PARKSIDE MONTESSORI MPR AND SITE PROJECT

ADDENDUM NO. 4

Date: November 21, 2023

Project: Parkside Montessori MPR & Site Project
DSA #: 01-120306 41-26

1 FUTURE LUNCH SHELTER ELECTRICAL SITE PLAN
SCALE: 1/8" = 1'-0"
N.I.C. - LUNCH SHELTER STRUCTURE WILL BE UNDER SEPARATE PROJECT

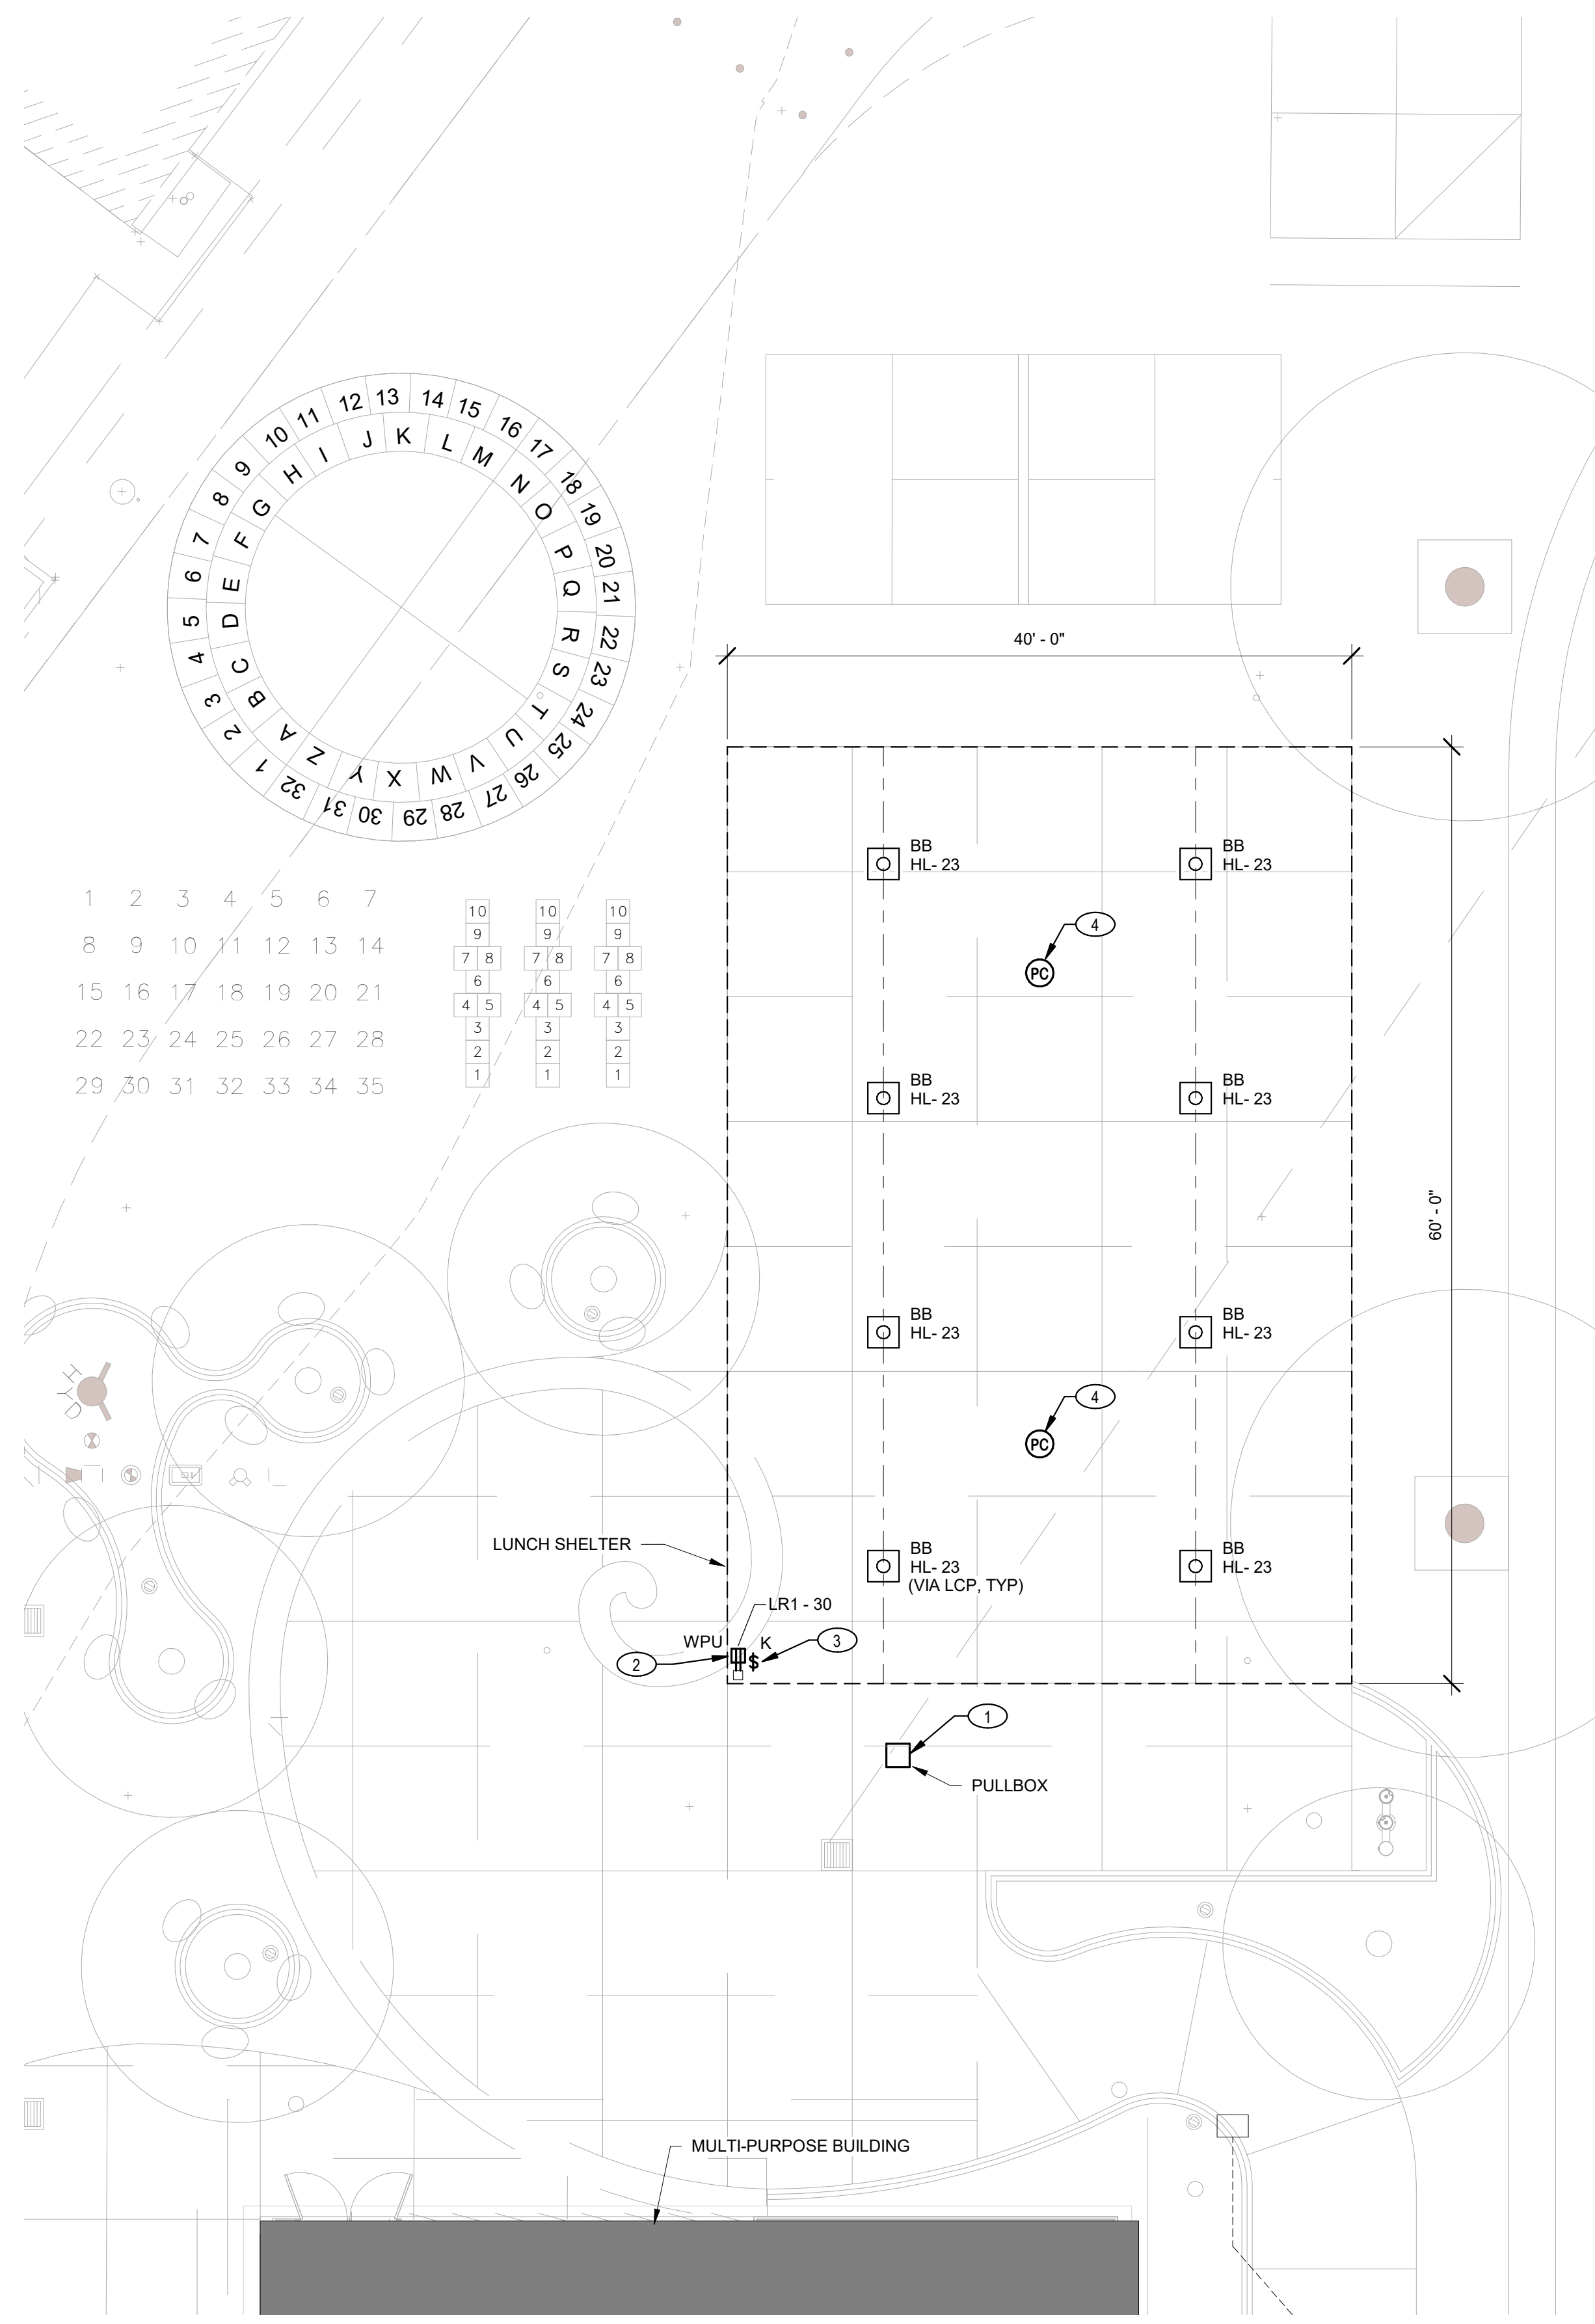
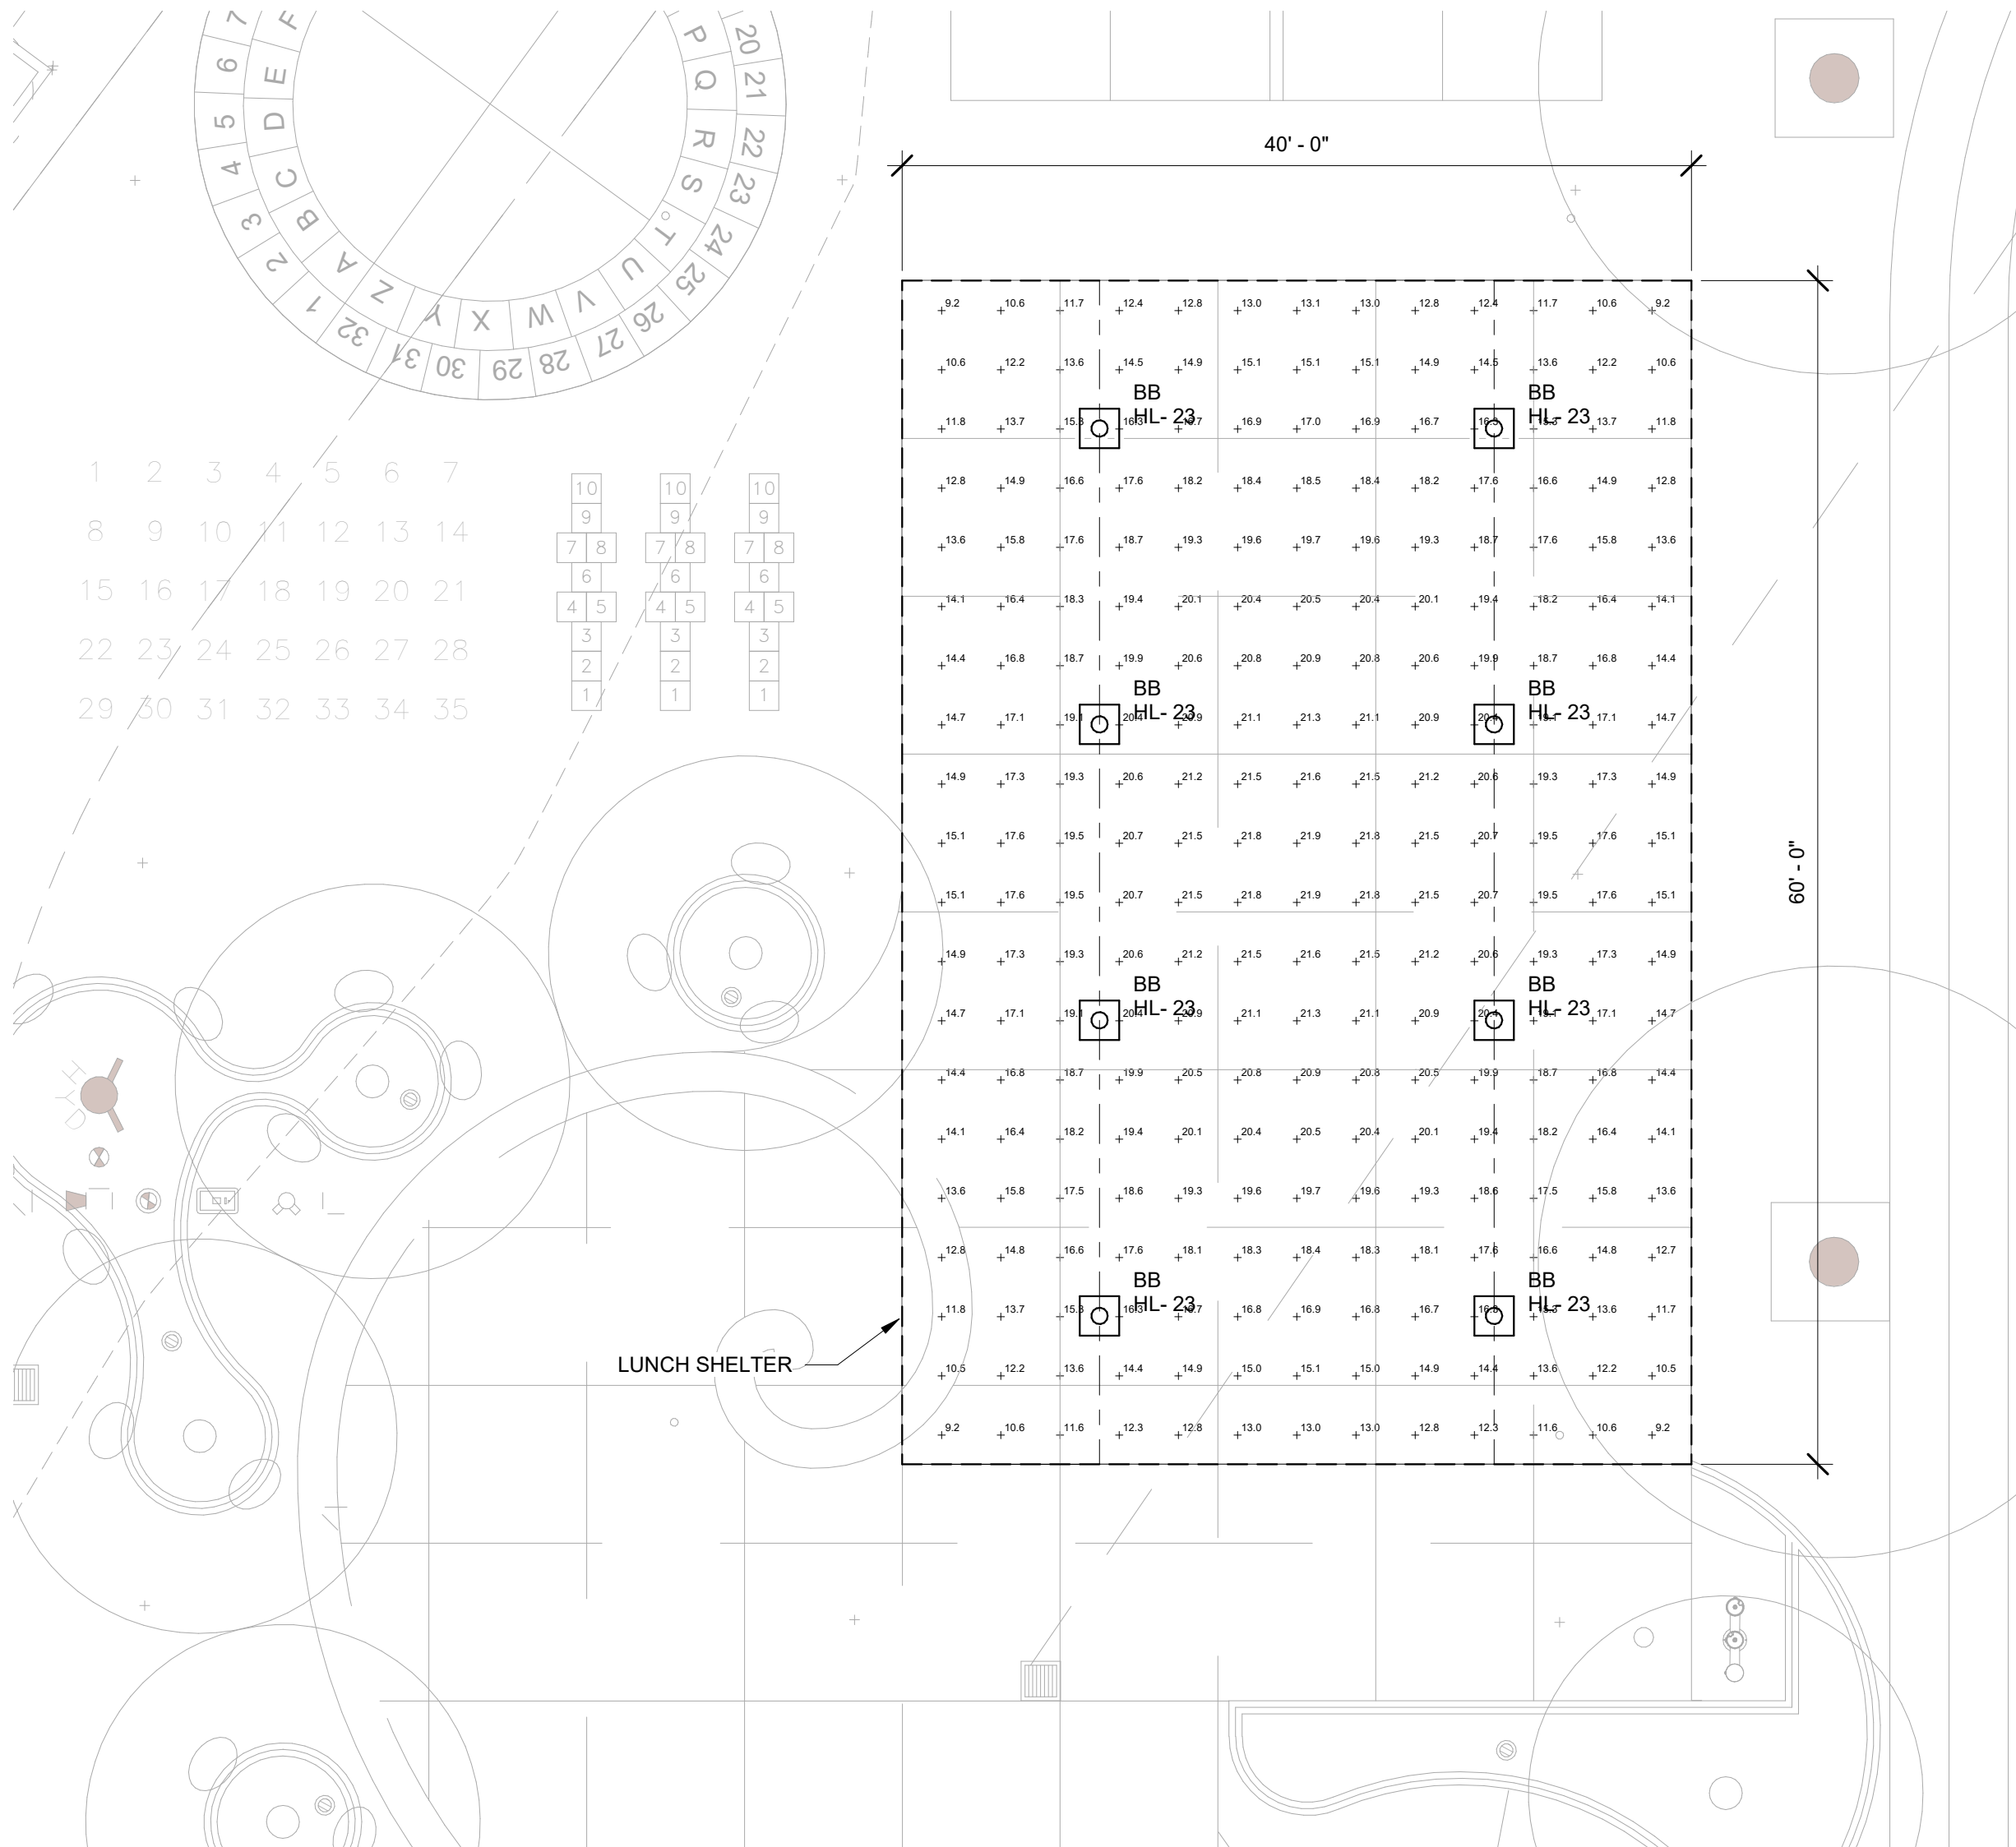
16. SHEET ‘E1.1A - LUNCH SHELTER ELECTRICAL SITE PLAN & PHOTOMETRIC PLAN’

- A. Added photometrics and electrical plan.
- B. Contractor shall coordinate the electrical and lighting scope with lunch shelter installer and its location and foundations.
